DrawDiff Comparison Report

Part number: P-001 | Job: 0d0fa489-3b7a-4e8c-8ceb-01810602e58c | Generated: 2026-05-05T01:02:48+00:00

ISO_VIEW_LEFT [MATCHED]

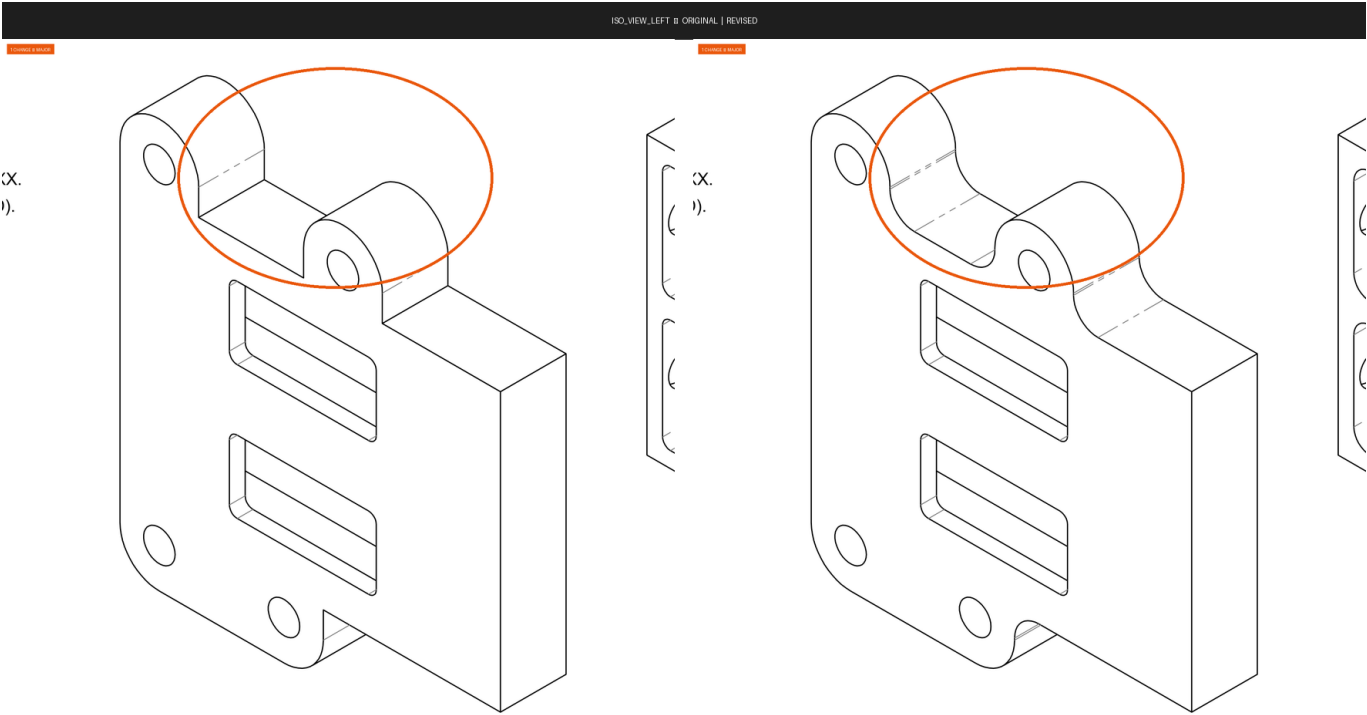
Severity	Field	Zone	Original	Revised	Conf.	Rationale
SIGNIFICANT	geometry	A4	Flat/stepped top surface on upper hinge block with sharp rectangular cross-section transition	Curved/filleted top surface on upper hinge block with continuous rounded profile blending into main body	0.82	The upper hinge/clevis block geometry has changed from a flat-topped stepped profile to a continuously curved rounded profile, indicating a significant shape change to that feature that would affect manufacturing and potentially structural behavior.

ISO_VIEW_RIGHT [MATCHED]

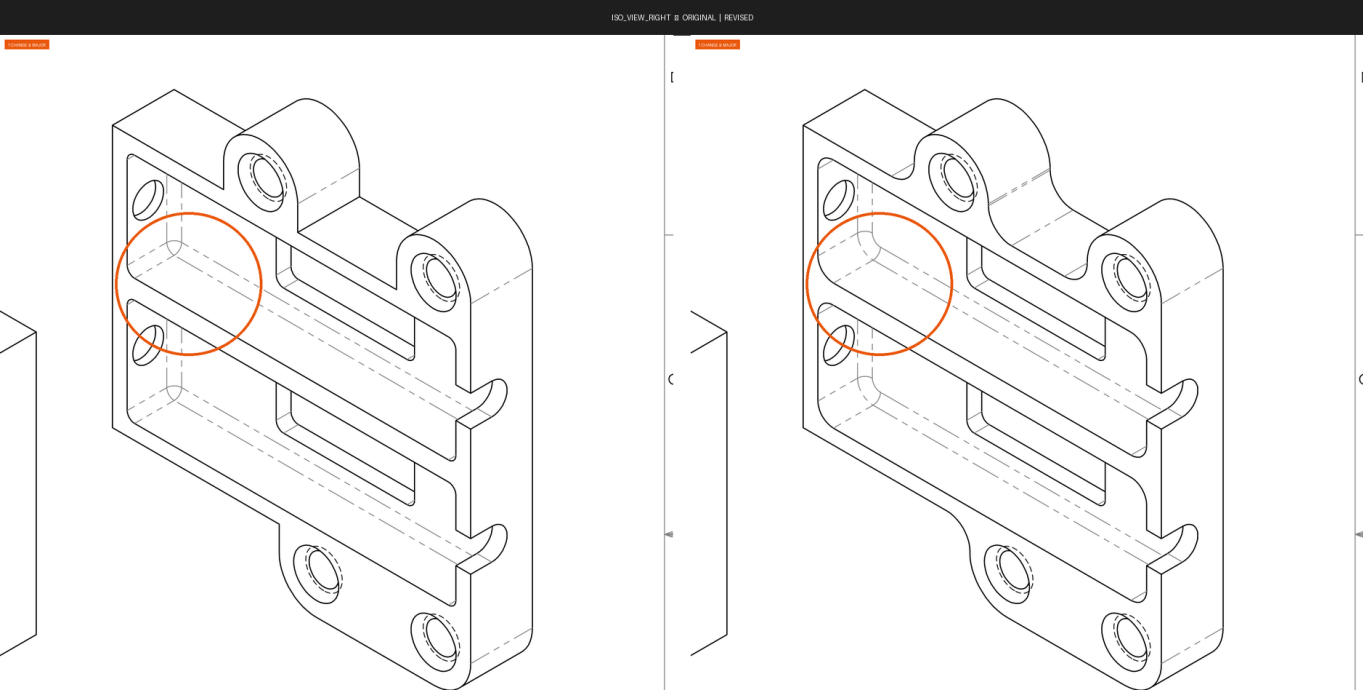
Severity	Field	Zone	Original	Revised	Conf.	Rationale
SIGNIFICANT	geometry	B3	Sharp/stepped inner corner at top-left pocket transition (upper slot region shows a distinct step or sharp corner profile)	Radiused/filleted inner corner at top-left pocket transition (corner is now blended with a visible fillet)	0.72	The interior corner geometry at the upper-left pocket wall appears to transition from a sharp or stepped corner in the original to a filleted radius in the revised view, which affects stress concentration and manufacturing process.

SECTION B-B [MATCHED]

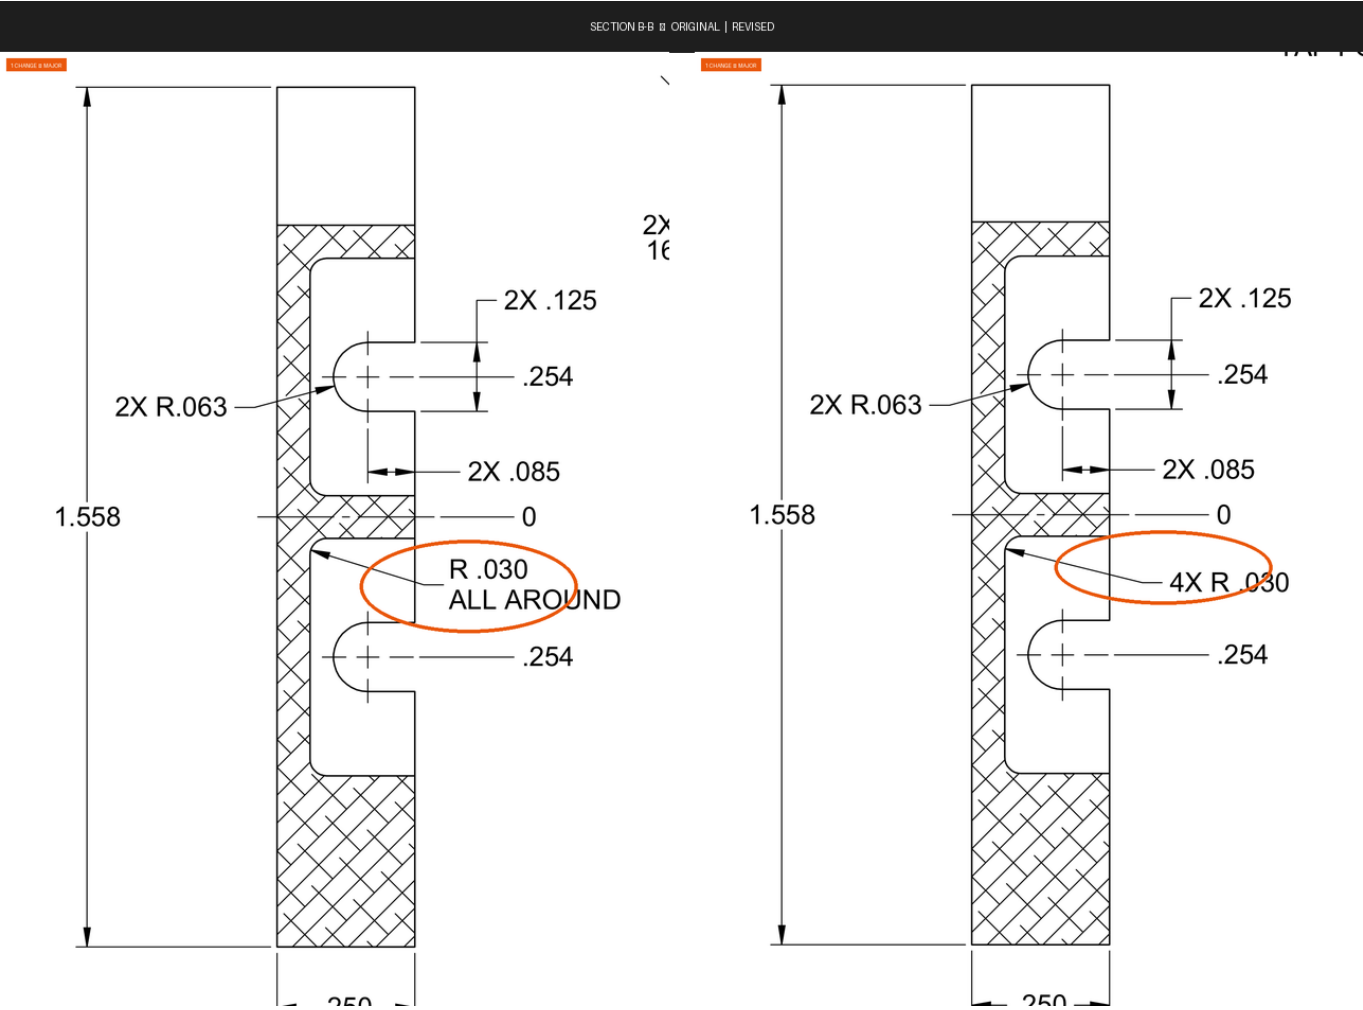
Severity	Field	Zone	Original	Revised	Conf.	Rationale
SIGNIFICANT	callout	B7	R .030 ALL AROUND	4X R .030	0.92	The radius callout changed from 'R .030 ALL AROUND' to '4X R .030', replacing the all-around modifier with an explicit count of 4 instances, which changes how the radius specification is interpreted and applied to the feature.

FRONT_VIEW [MATCHED]

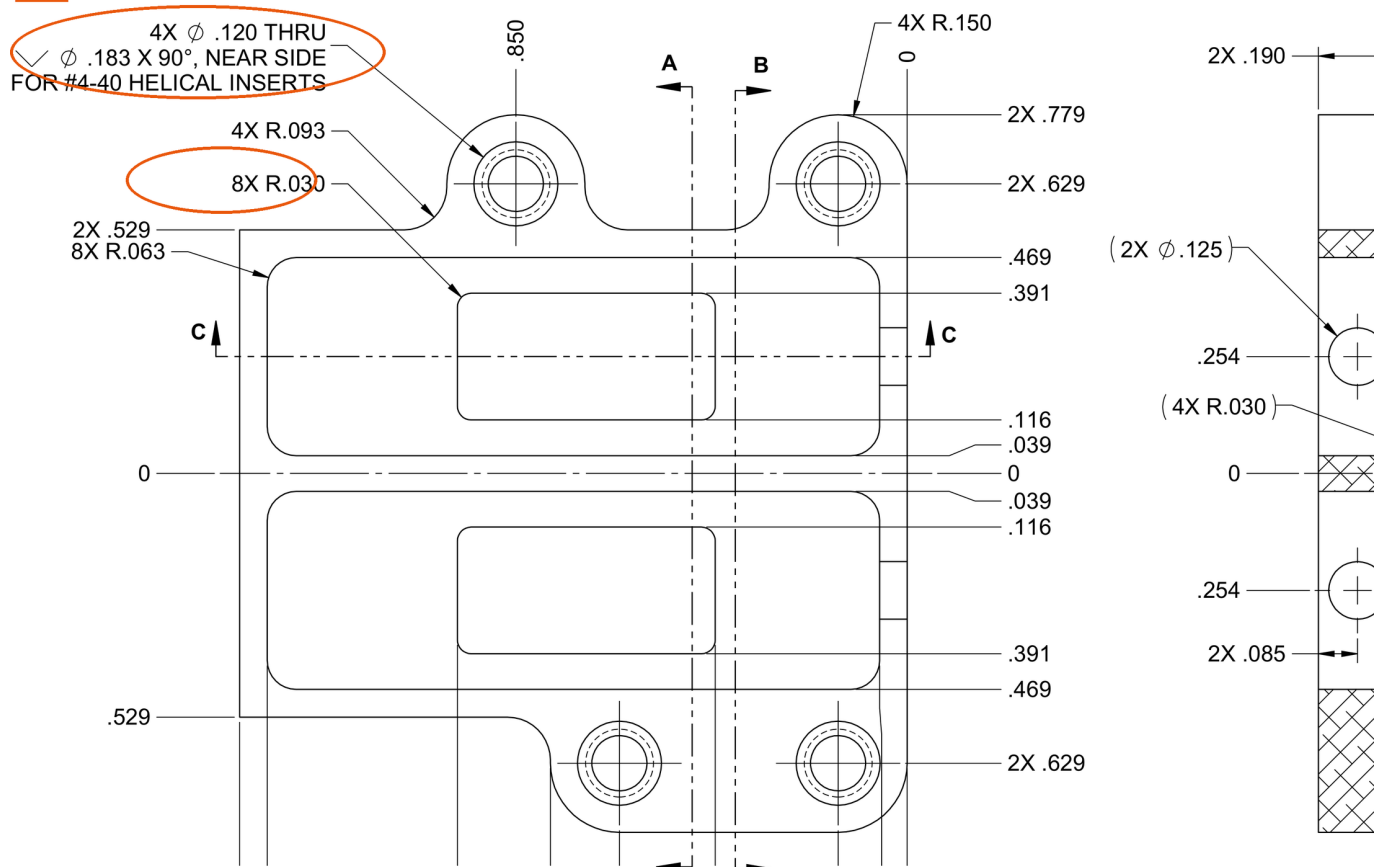
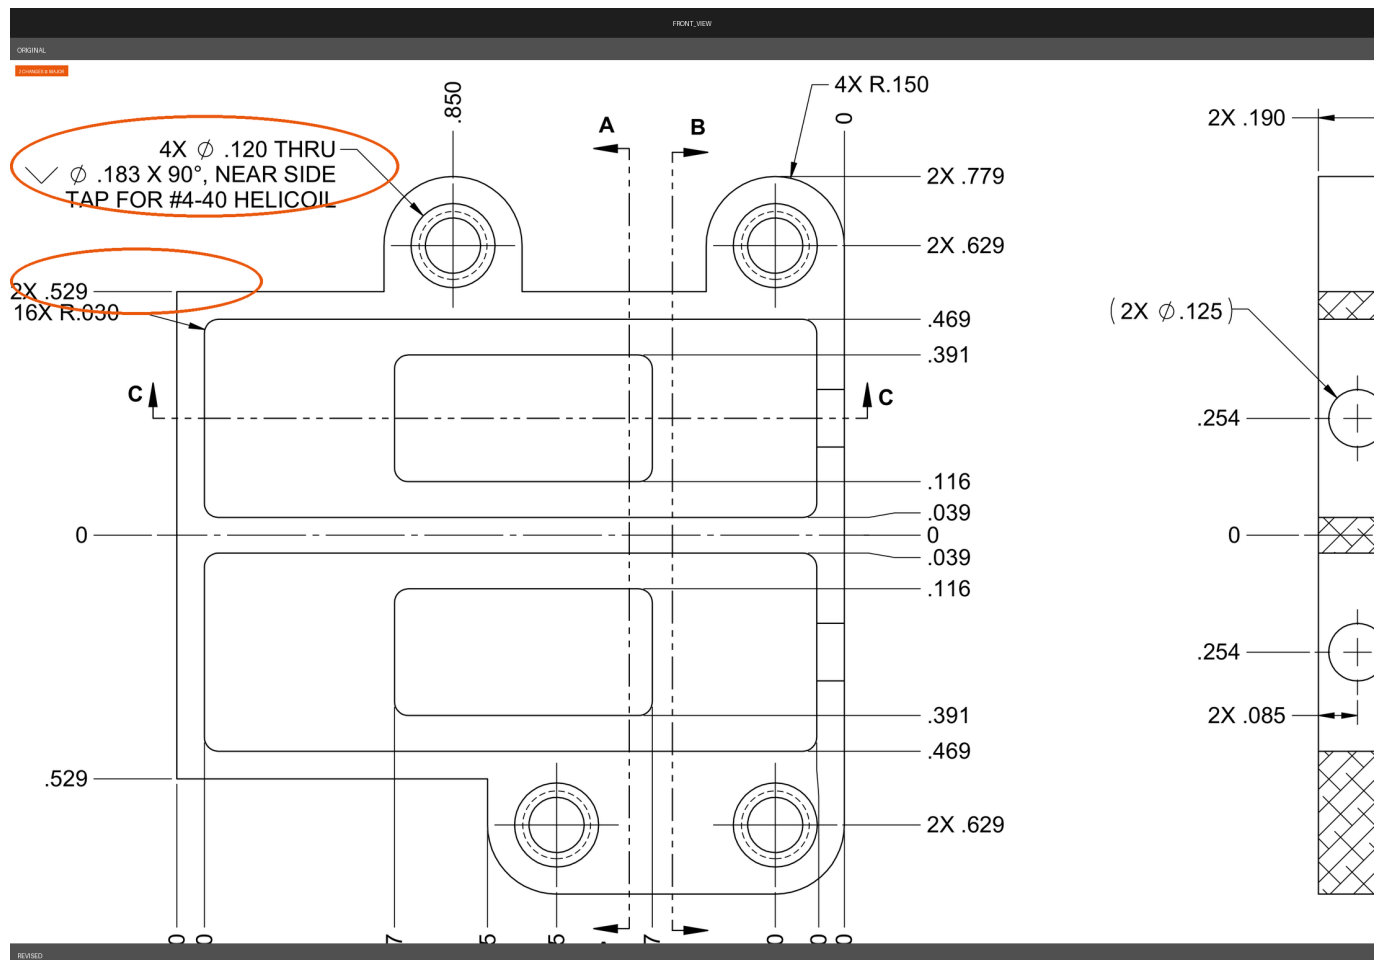
Severity	Field	Zone	Original	Revised	Conf.	Rationale
SIGNIFICANT	note	A6	TAP FOR #4-40 HELICOIL	FOR #4-40 HELICAL INSERTS	0.95	The tap specification note was changed from 'TAP FOR #4-40 HELICOIL' to 'FOR #4-40 HELICAL INSERTS', indicating a change in insert type/brand specification which affects procurement and manufacturing.
SIGNIFICANT	annotation	A6	16X R.030	8X R.030	0.92	The quantity of R.030 radii in the upper area was changed from 16X to 8X, indicating fewer instances of this corner radius feature on the part.

SECTION A-A [MATCHED]

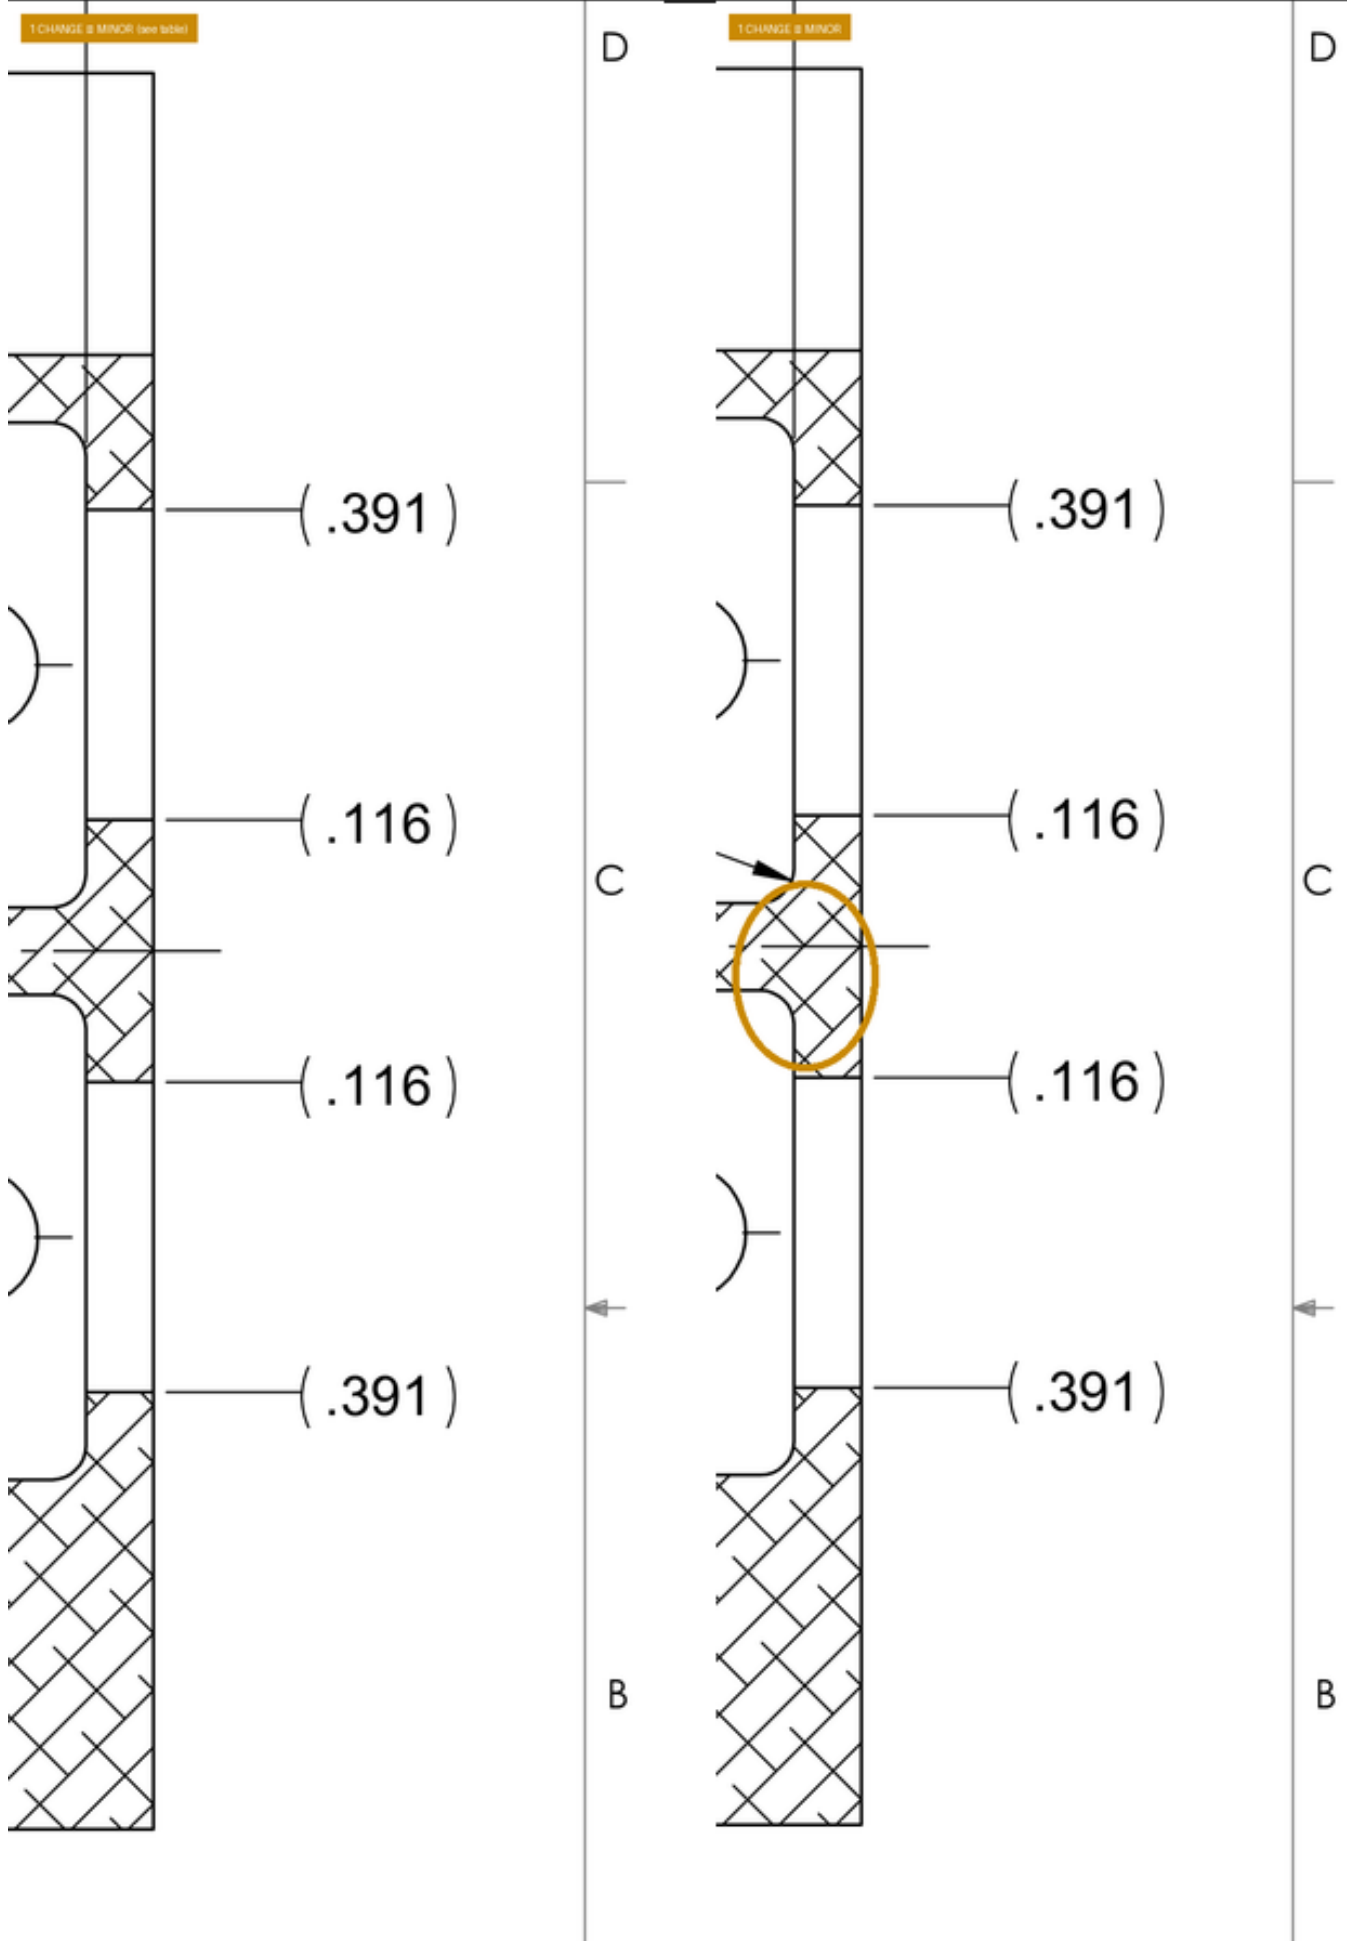
Severity	Field	Zone	Original	Revised	Conf.	Rationale
MINOR	annotation	B1	—	arrow/leader pointing to groove/ undercut feature	0.72	A small filled arrow or leader annotation appears in the revised view near the mid-section groove area (left side, around the .116 dimension zone) that is not present in the original, possibly indicating a new callout or pointer to a specific feature.

SECTION C-C [MATCHED]

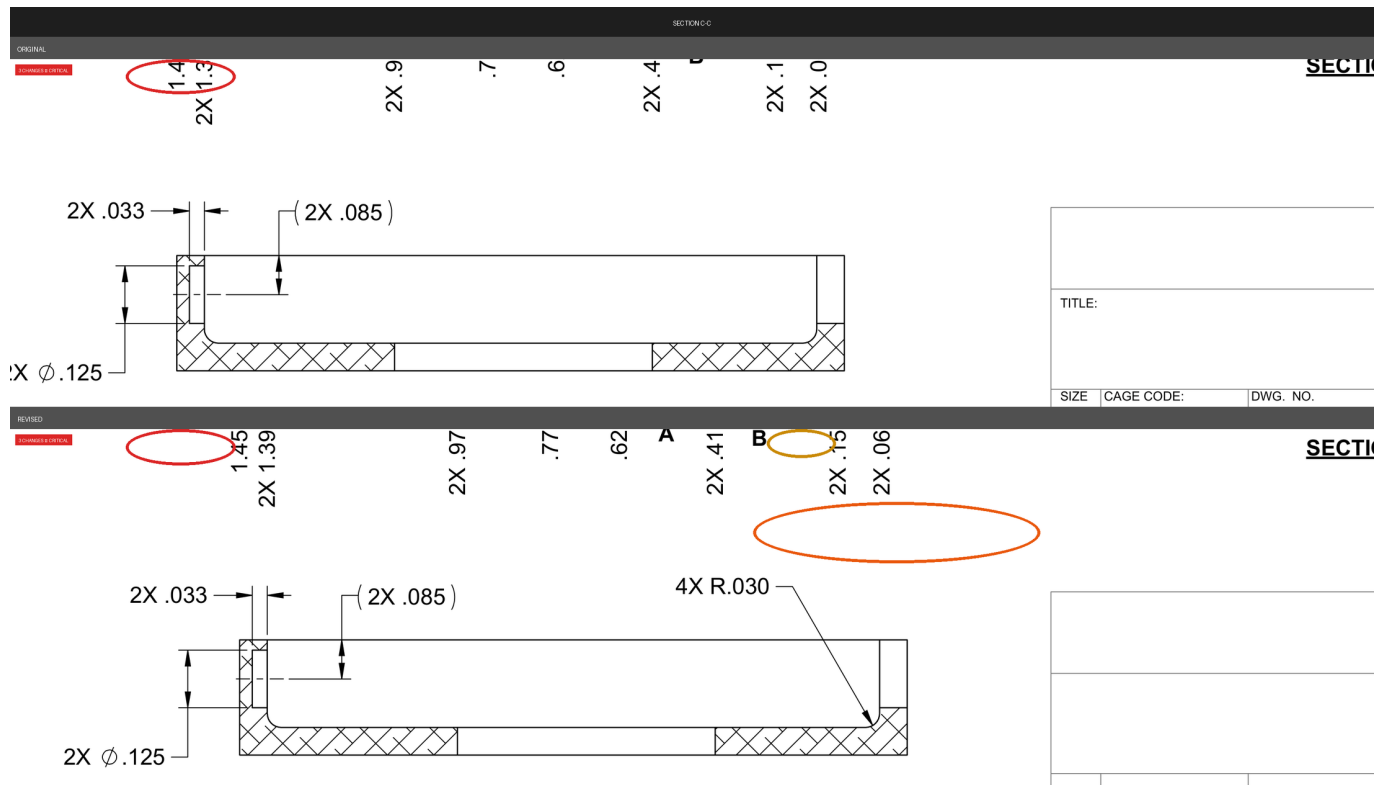
Severity	Field	Zone	Original	Revised	Conf.	Rationale
CRITICAL	dimension	C6	1.4	1.45	0.82	Overall length dimension changed from 1.4 to 1.45, a functional change affecting part fit and envelope.
SIGNIFICANT	callout	D3	—	4X R.030	0.90	A new radius callout '4X R.030' has been added in the revised drawing, specifying corner radii on four locations not previously called out.
MINOR	annotation	C4	—	A	0.75	A new section/datum label 'A' appears in the revised drawing at the top dimension row, not present in the original.
